VISUAL RESOURCES RESPONSES

Inland Empire Energy Center, LLC
Inland Empire Energy Center

Data Requests and Responses (01-AFC-4) Set #1A as a part of the licensing procedures for the East Altamont Energy Center.

Photo DR 137-1. View looking west toward wastewater treatment plant. Agricultural education area is visible at right.

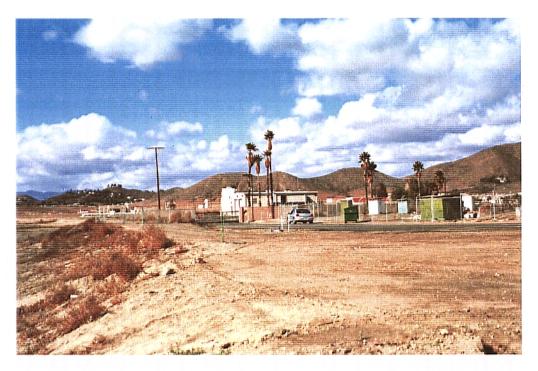
Photo DR 137-1 is a view of the Sun City RWRF where the non-reclaimable wastewater line serving the IEEC will begin. The Sun City RWRF is located on the north side of the Salt Creek Channel and is set back approximately 1,000 feet from Murrieta Road. A paved road providing access to the wastewater facility passes through the setback area, and a portion of the setback is a fenced area used for agricultural education by a local high school. The rest of the setback area consists of bare, undeveloped land.

Photo DR 137-2. View looking north along Murrieta Road. Setback area in front of wastewater treatment plant is visible on left. Hedge on right side of street screens back lot lines of homes in Rancho del Sol residential community.

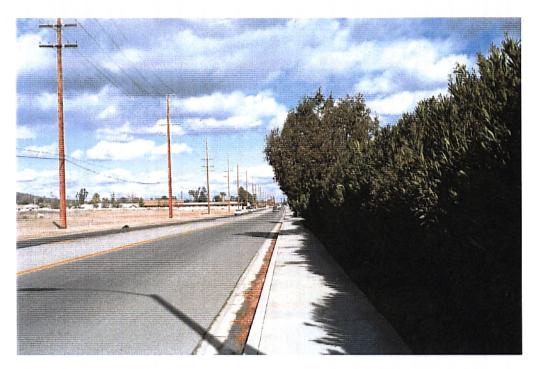
Photo DR 137-2 is a view looking north along Murrieta Road in the area in front of the wastewater treatment facility. The vacant setback area in front of the wastewater treatment plant is visible on the west (left) side of the street. The vegetation on the right side of the street is a hedge along the edge of the Rancho del Sol residential community, where because the homes front on interior streets, there are no homes fronting on Murietta Road.

In the areas along Murrieta Road at the southern and northern ends of Sun City represented by Photos DR 137-2 and DR 137-4, the sensitivity to potential visual impacts of pipeline construction is low because there are few or no residences that look directly onto the street where the pipeline construction will take place.

Photo DR 137-5. View looking east on McLaughlin Road, immediately east of Murrieta Road. On the north side of the road is an electric transmission corridor accommodating a 115 and a 500 kV line.

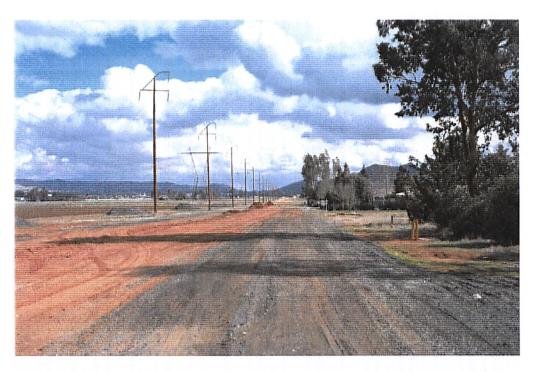
Photo DR 137-5 is a view looking east on McLaughlin Road, immediately east of Murrieta Road. In this area, the pipeline right of way lies under an unpaved segment of McLaughlin Road. The pipeline route passes by a one block area of low density rural residential development, and then extends approximately 0.65 mile eastward through an area of open agricultural land before reaching Interstate 215. The area on the north side of the road is occupied by an electric transmission corridor that now accommodates a 115 and a 500 kV line. In this view, Interstate 215 is visible as the white line that defines the far end of the open fields visible in the middleground.

In the portion of the pipeline route that lies in McLaughlin Road in the area between Murrieta Road and the power plant site (Photos DR 137-5, -6, and -8), the sensitivity to pipeline construction visual impacts is particularly low. In these areas, the unpaved roadway already has a disturbed appearance. To the extent to which there are rural residences in the vicinity of this portion of the route views toward the pipeline right of way are buffered by distance, and in some cases, by the presence of screening vegetation. In the area along McLaughlin Road near Encanto Drive where there is a standard subdivision (Photo DR 137-7) the visual sensitivity is low because none of the homes front onto McLaughlin Road.

Photo DR 137-6. View looking east on McLaughlin Road, immediately east of the rural residential area. Interstate 215 is visible as the horizontal line at the far end of the area of open fields visible in the foreground and middleground.

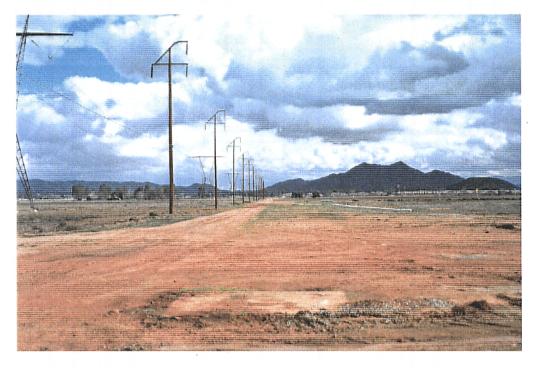
Photo DR 137-6 is a view looking east on McLaughlin Road, from a viewpoint immediately to the east of the rural residential area visible in Photo 5. In this view, the open agricultural lands on both sides of McLaughlin Road can be seen. In addition, this photo provides an unobstructed view of the agricultural/infrastructure character of the lands alongside Interstate 215 in the area where the pipeline right of way crosses under the freeway.

Photo DR 137-8. View looking east on McLaughlin Road at the intersection of Trumble Road.

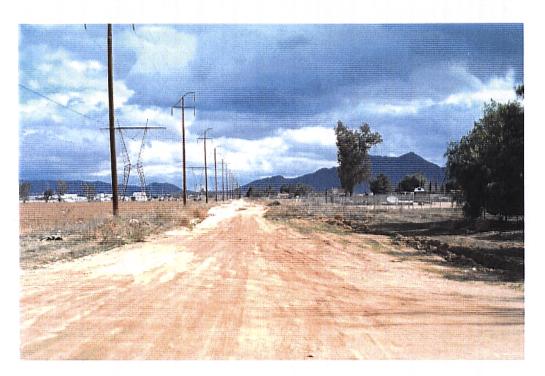
Photo DR 137-8 is a view looking east along McLaughlin Road from its intersection with Trumble Road. This view is typical of the conditions that exist for the approximately 0.8 mile segment of the right of way that extends from Trumble Road to the project site. In this area, McLaughlin Road is unpaved, and is bordered by the 115/500 kV transmission corridor on the north. For the most part, the land on the north side of the road consists of open parcels in agricultural use; the exception is at the intersection of Dawson Road, where there is a cluster

Figure 141-1

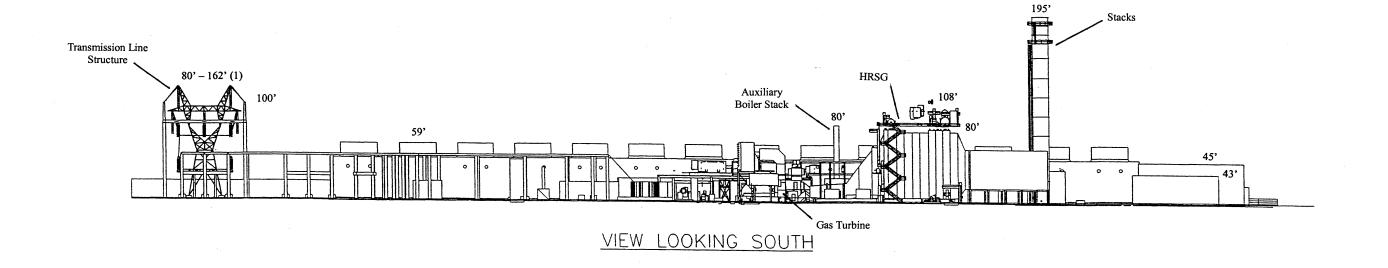
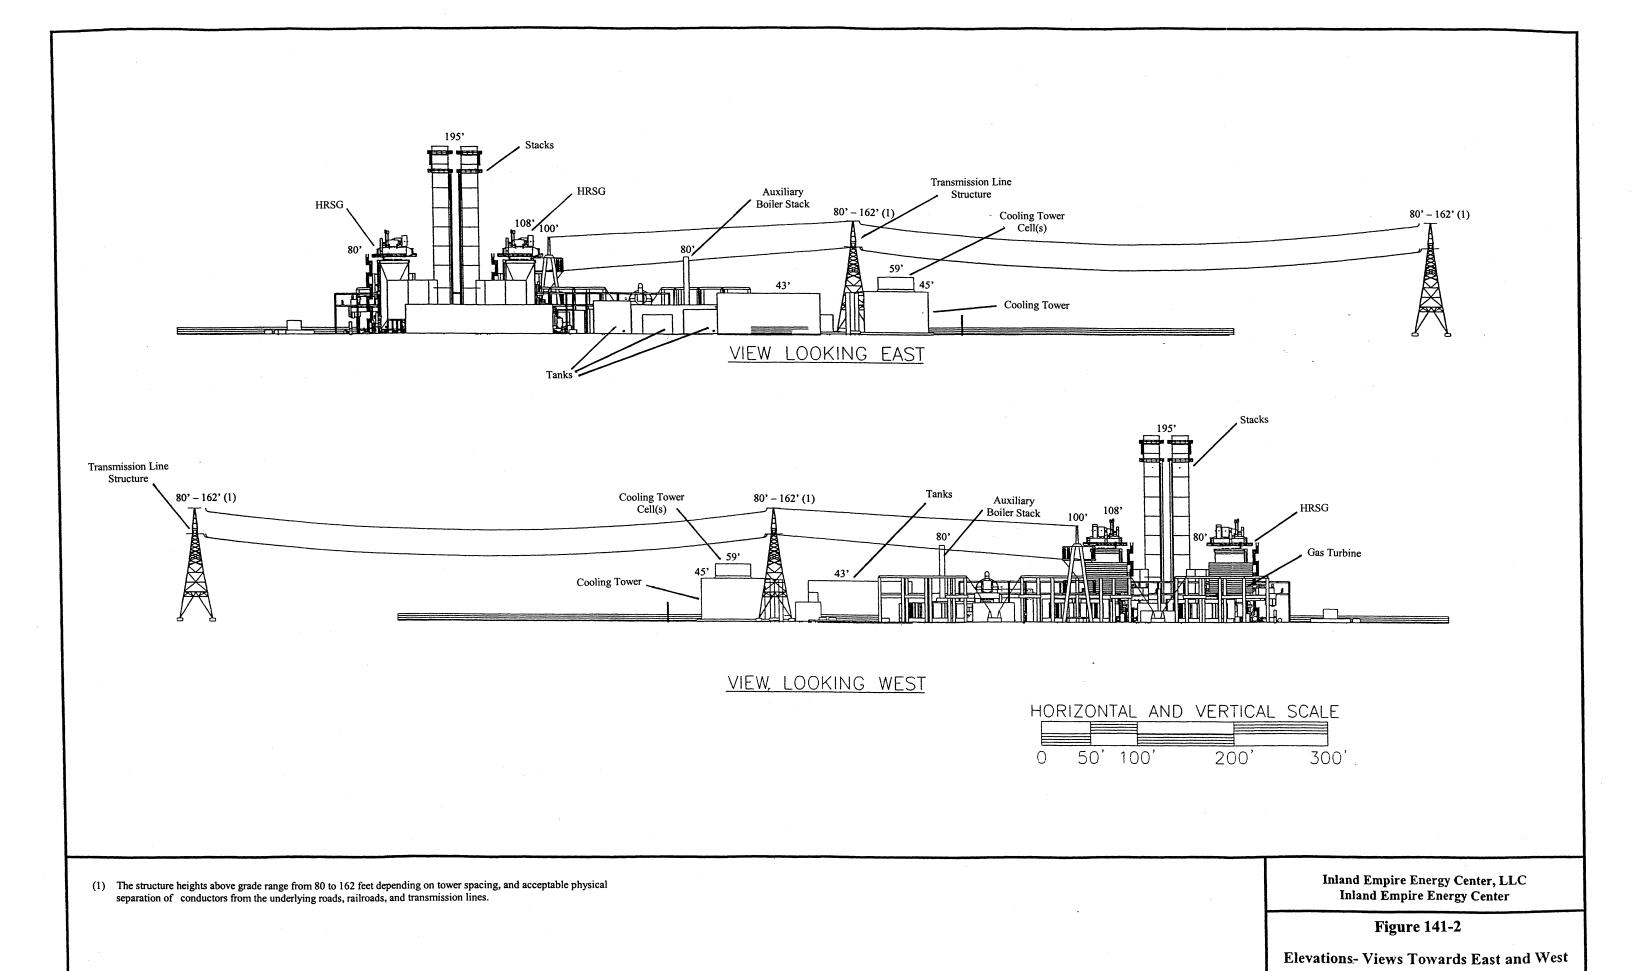
Request #141 - Please revise Figures 3.4-1 and 3.4-2 to identify structures and specify their heights.

Response #141 - Figures 3.4-1 and 3.4-2 have been revised to identify the primary site structures and heights above ground level. These revised figures are numbered 141-1 and 141-2. (See following pages.)

Figure 148-1 Identified Plume/Sources in Project Area anticipated vegetation heights and five years and at maturity, and (c) the time to maturity for each species to be planted.

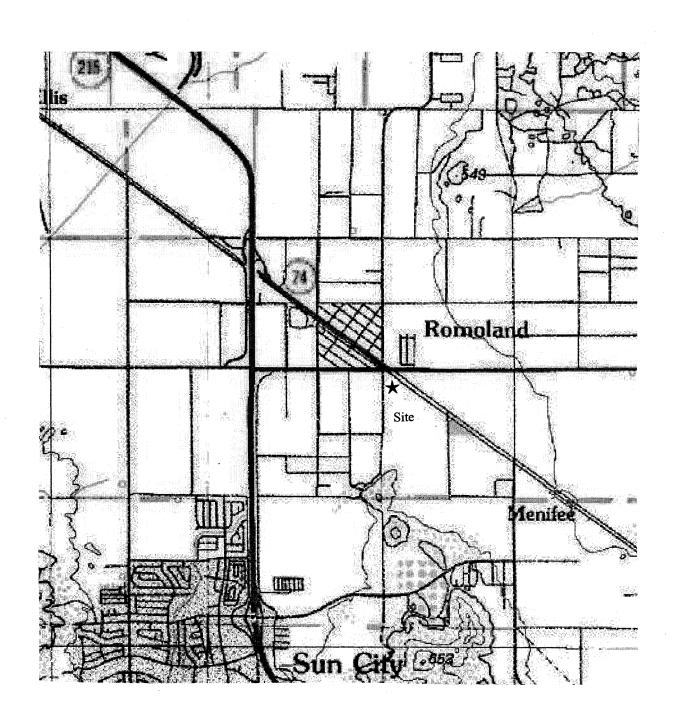
Request #148 - Please describe and map any other plume sources in the proposed project region.

Response #148 - Two separate visual surveys were conducted in the project region to identify the existence of visual plume sources.

Figure 148-1 shows the location of the one identified plume source per the visual surveys.
